Changing assigned Class through DLL v101

Info (not part of baseline)

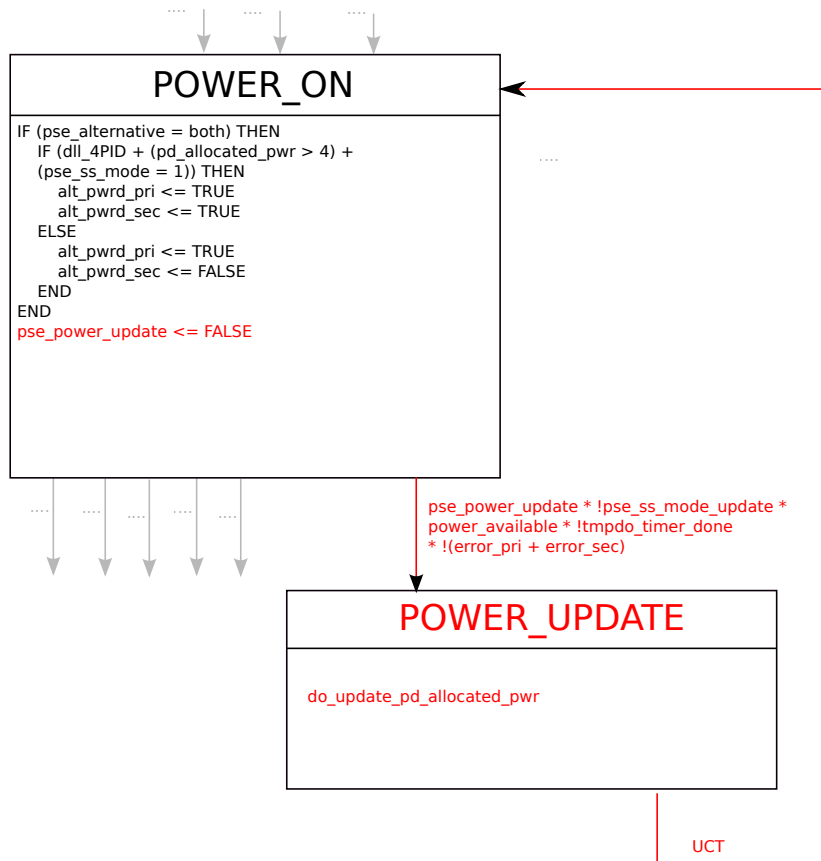
33.2.5.12 Type 3 and Type 4 state diagrams

Change Figure 33–15 on page 95 as follows:

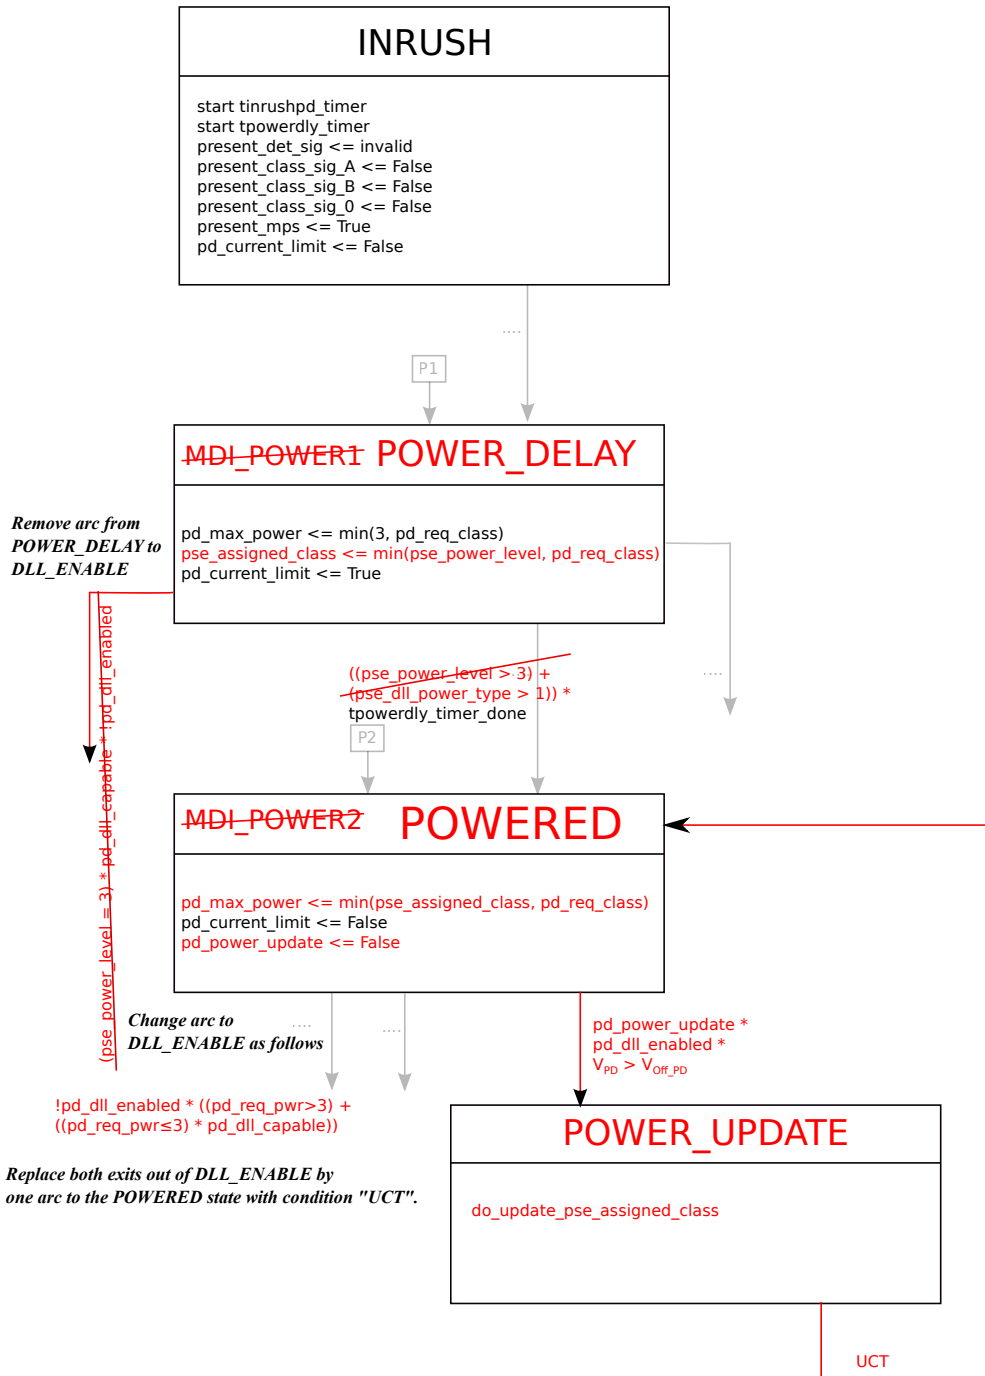
33.3.3.11 Type 3 and Type 4 single-signature PD state diagrams

Change Figure 33–32 as follows:

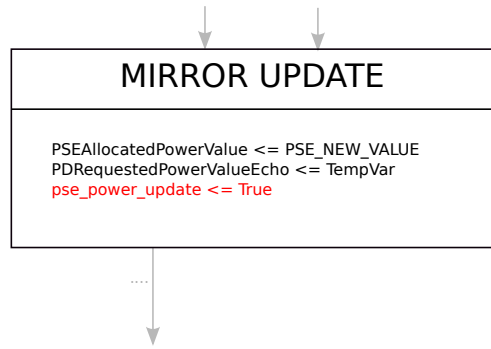
The following non-normative text is added to explain that it is not permitted to draw more power than the requested Class. The actual requirement is in the PD state diagram, as well as on D2.2, page 153, line 47.

After a successful DLL classification, the assigned Class changes depending on the value of PDMaxPowerValue variable, as defined in Table 33–24. A PD may be able to get a Class assigned that is higher than its requested Class, however it is not permitted to draw more power than what corresponds to the PDs requested Class.
